## UNITARY PLAN UPDATE REQUEST MEMORANDUM

**SUBJECT** **Plan Modification to the Auckland Unitary Plan (AUP)  
Operative in part (15 November 2016) – Plan Change  
43 (Private): McLaughlin’s Quarry**

## Decision following the hearing of a Private Plan Change under the Resource Management Act 1991 –

### Proposed Private Plan Change 43 –to the Auckland Unitary Plan

2) Amend the Outstanding Natural Features Overlay (ID 93 Matukuturua Lava Field and Explosion Crater) as shown below:

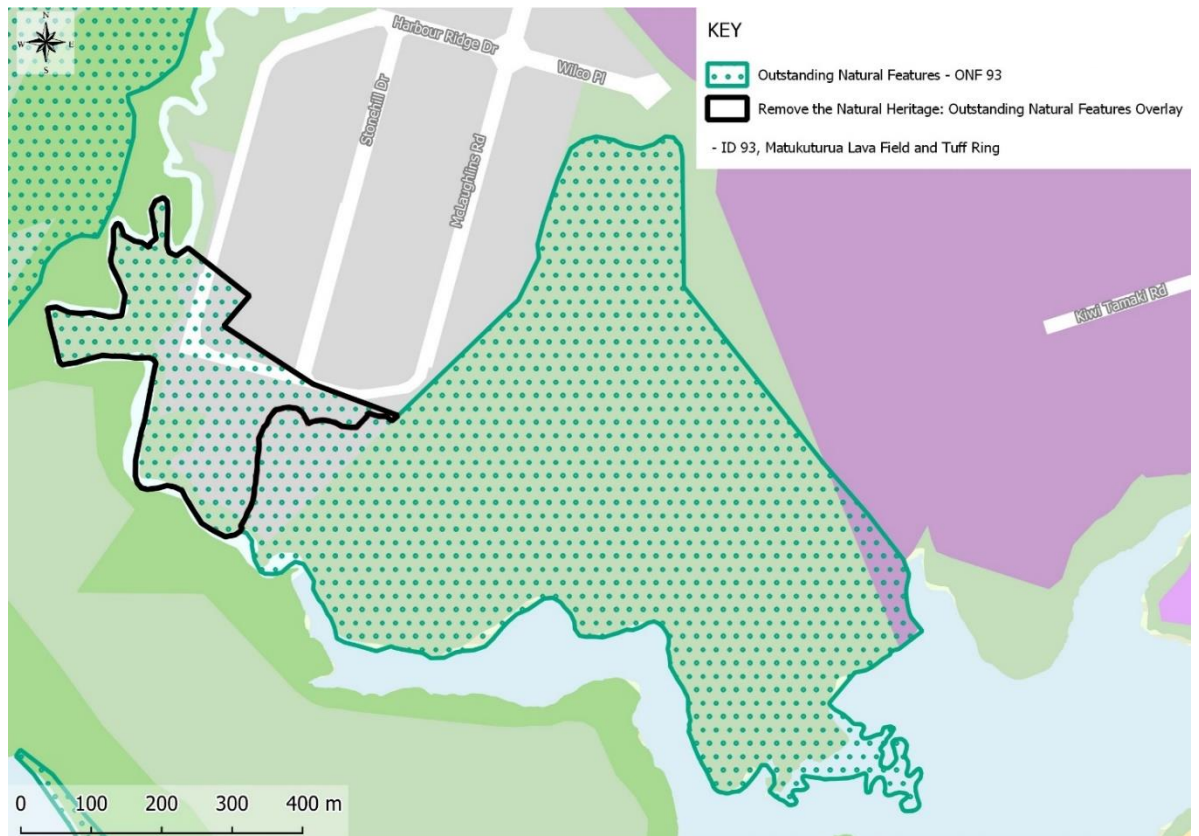
(Delete the map as notified, and replace it with the map as shown below)

##### **I4.9.1 Wiri Precinct Plan 1: Figure 1**

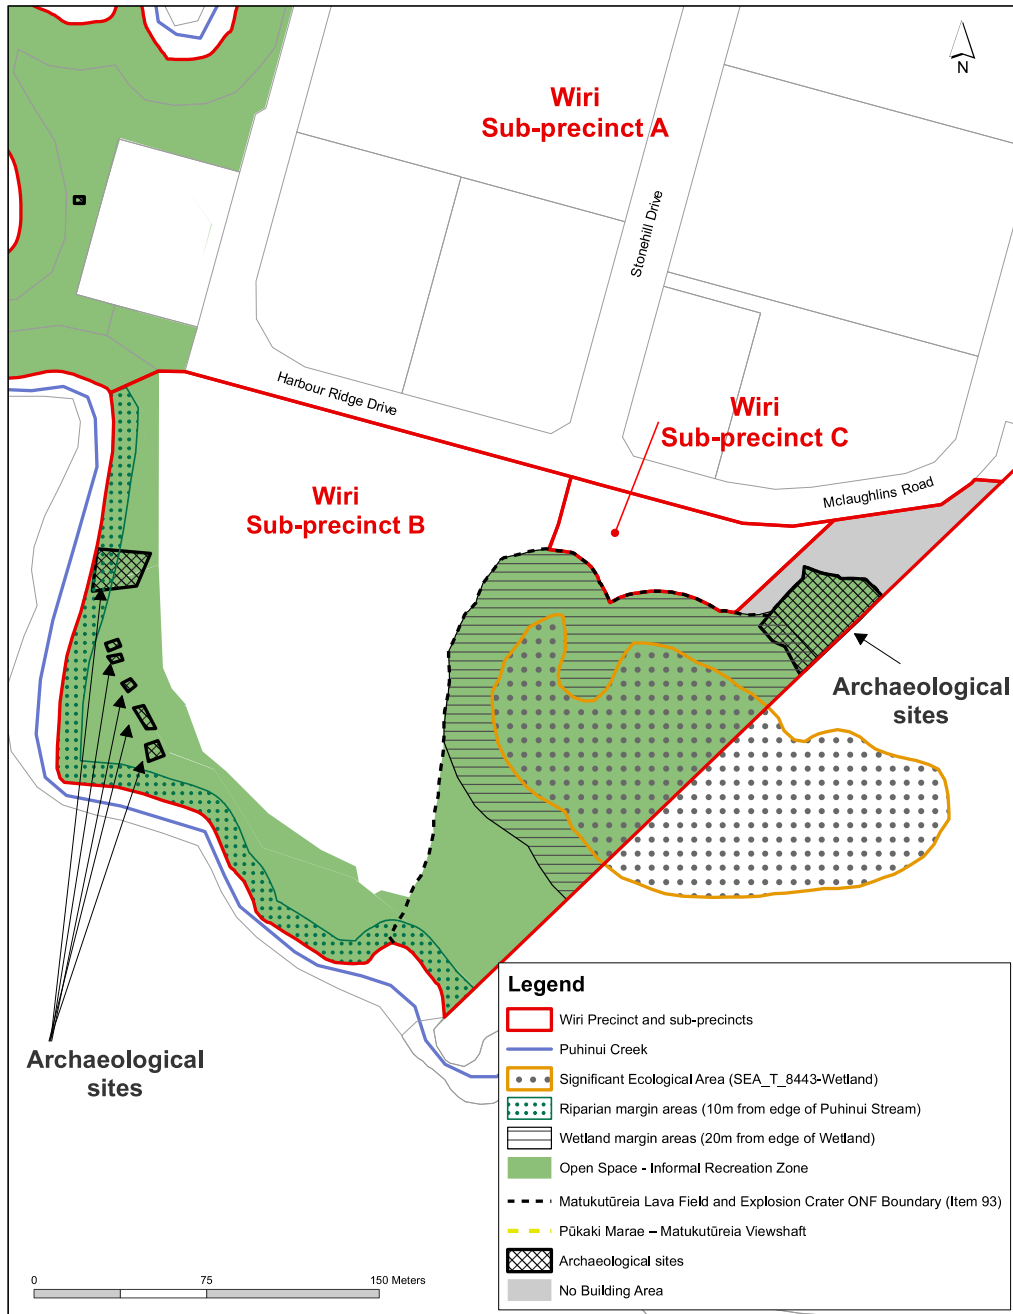
**(Delete Precinct Plan 1 as notified and replace it with the amended Plan shown below)**
